MPRS Enhancement for Improved Error Handling

Glen Kramer, Broadcom Ltd.

Adopt the State Diagrams and Definitions for transmission envelopes shown in kramer_3ca_1_0917 slides 10-21.

Existing Envelope Structure (D0.4)

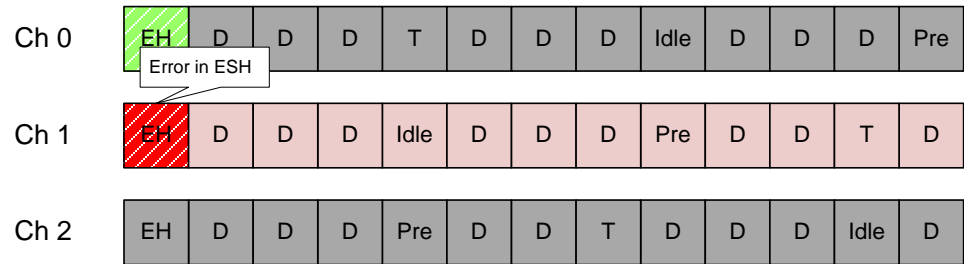
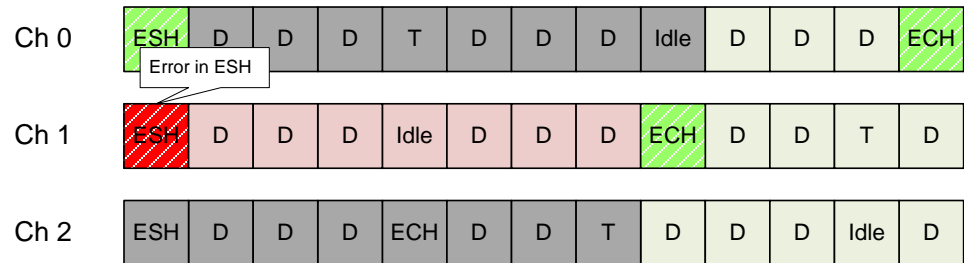
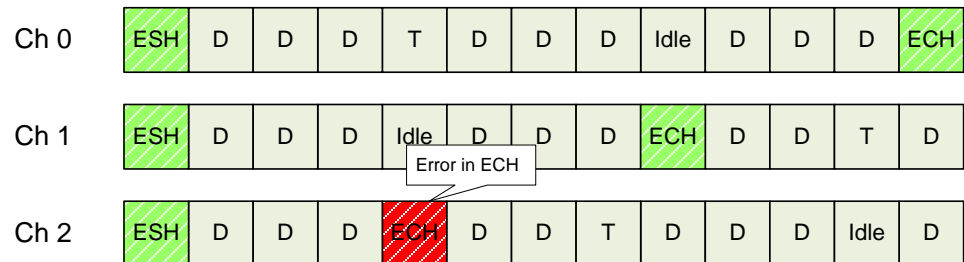
- ❑ In current version, an error in envelope header results in loss of multiple envelopes
- ❑ In new proposal, multiple frames may be lost, if the error happen in the ESH on one of the channels. But the data will recover when the next ECH is encountered on the affected channel.

Entire Envelope is Lost

Only two frames are lost

No frames are lost

Envelope Header (EQ format)

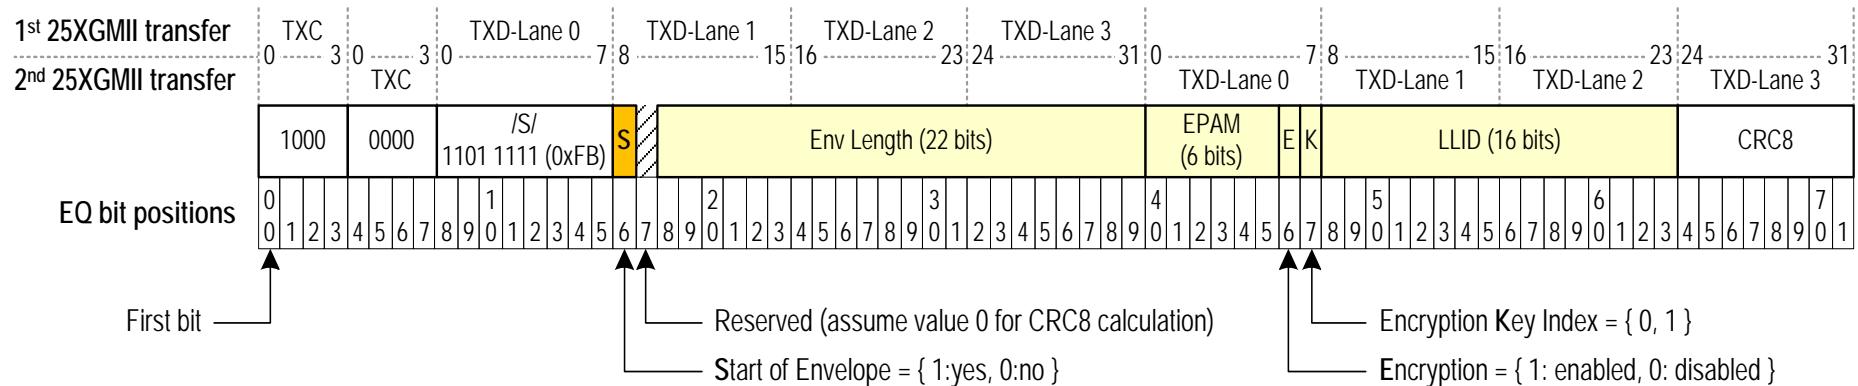
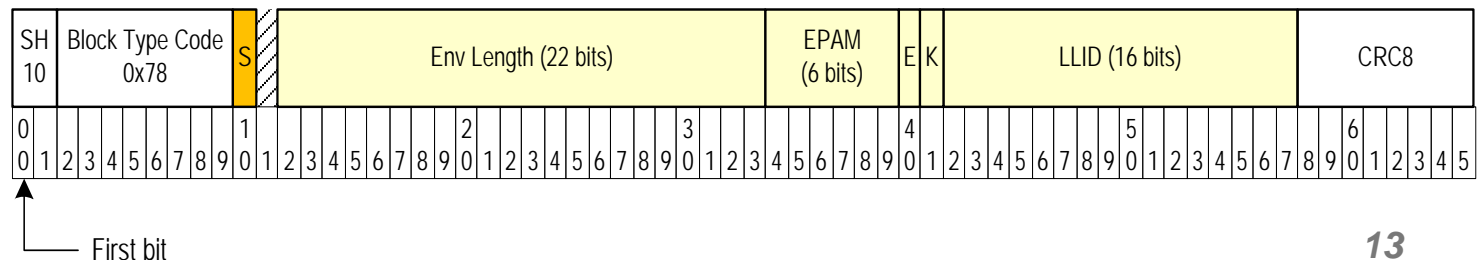
- Both ESH and ECH have identical formats
- The only difference is the value of the **Start** flag (replaces Preamble flag)
 - In ESH, Start = 1 (true)
 - In ECH, Start = 0 (false)

Figure 143-1—ONU MPRS Input Process state diagram

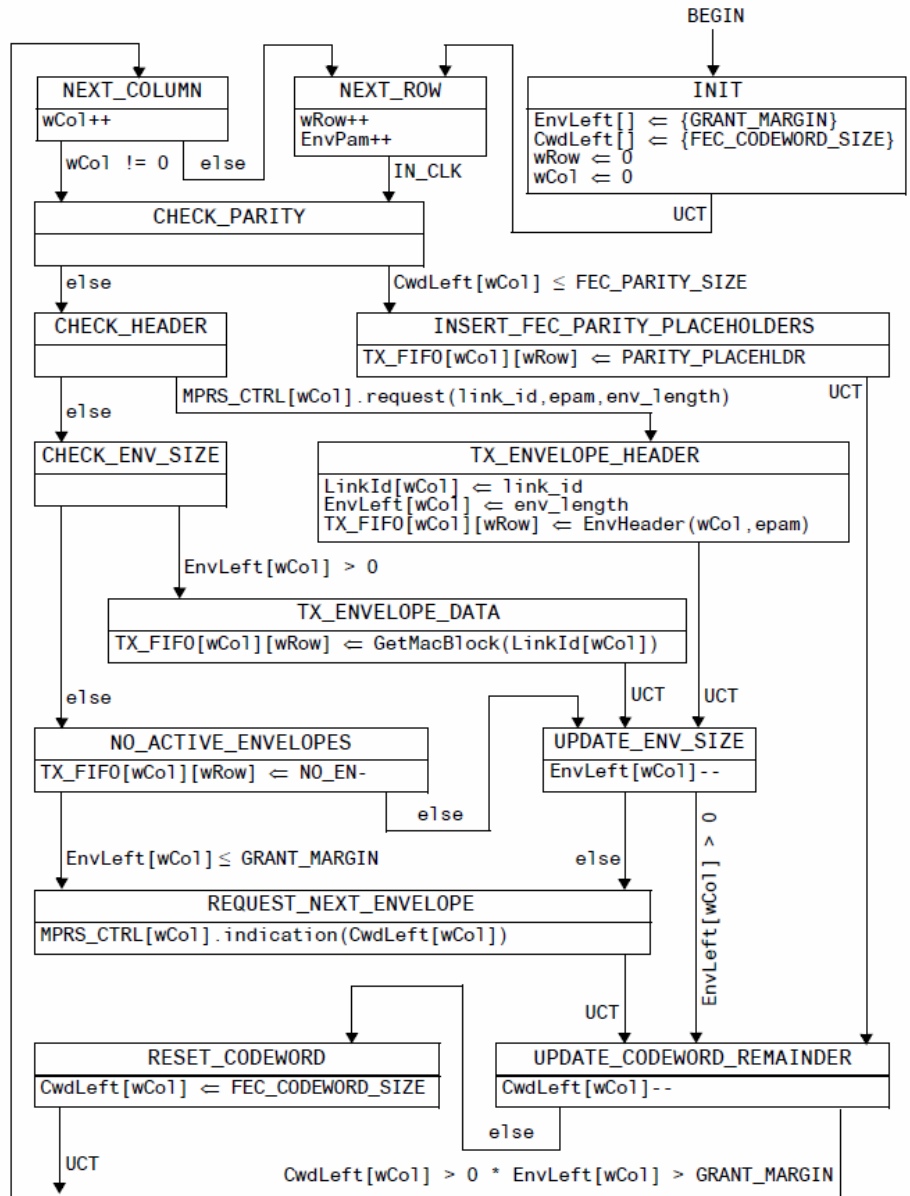
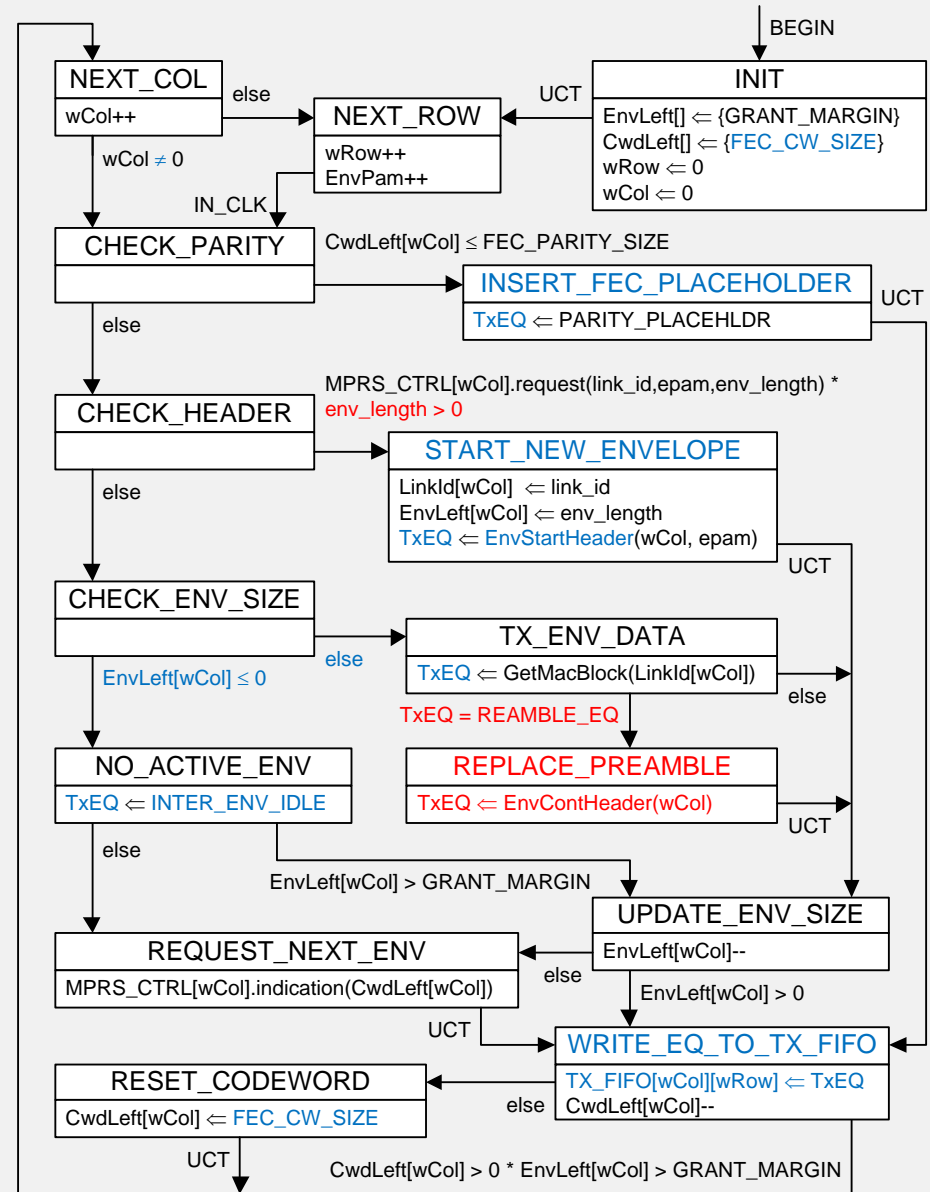
- Function **GetEnvHeader(...)** is replaced by two functions:
 - EnvStartHeader(...)** returns the value of ESH
 - EnvContHeader(...)** returns the value of ECH

- A new state **REPLACE_PREAMBLE** is added

1. Envelope length includes the envelope header. Therefore, an MPRS_CTRL.request() from MPCP with env_length = 0 is considered a malformed request and is ignored by MPRS Input Process.
2. Any time a preamble is read from the MAC, it is replaced in MPRS Input Process by a Envelope Continuation Header (ECH)
3. Any time a ECH is encountered by the MPRS Output Process, it is replaced by a normal frame preamble before the EQ is passed to the MAC.

Figure 143-4—OLT MPRS Output Process state diagram

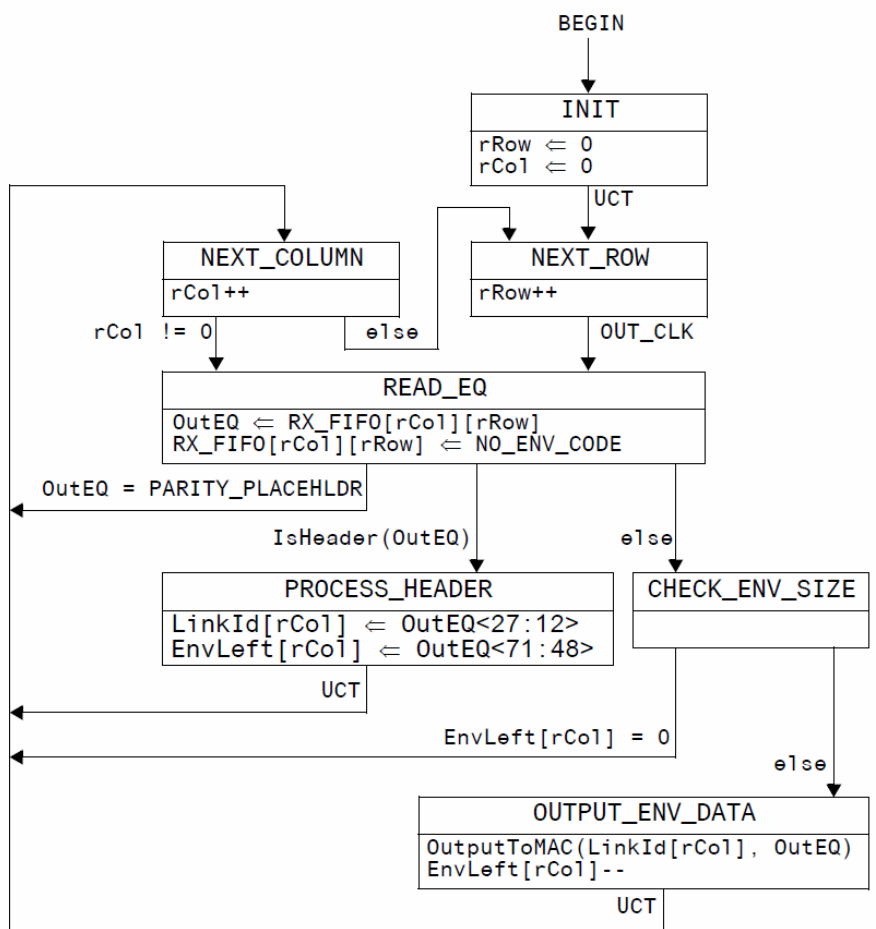
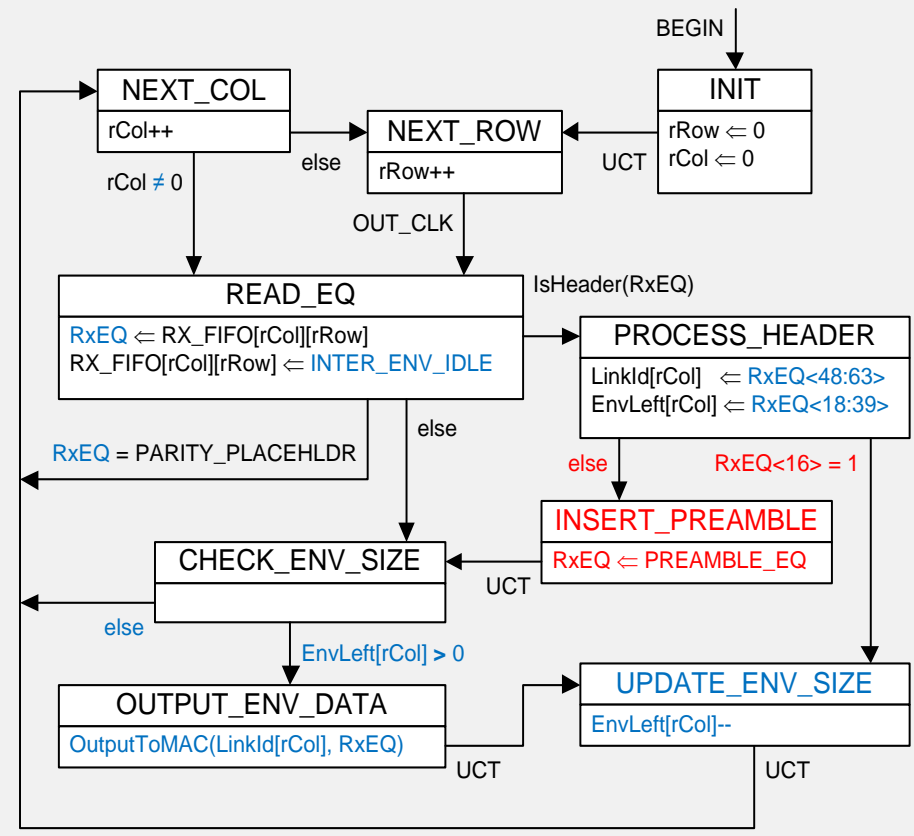
- Added state
INSERT_PREAMBLE
 - Replaces ECH with a regular preamble before passing RxEQ to MAC
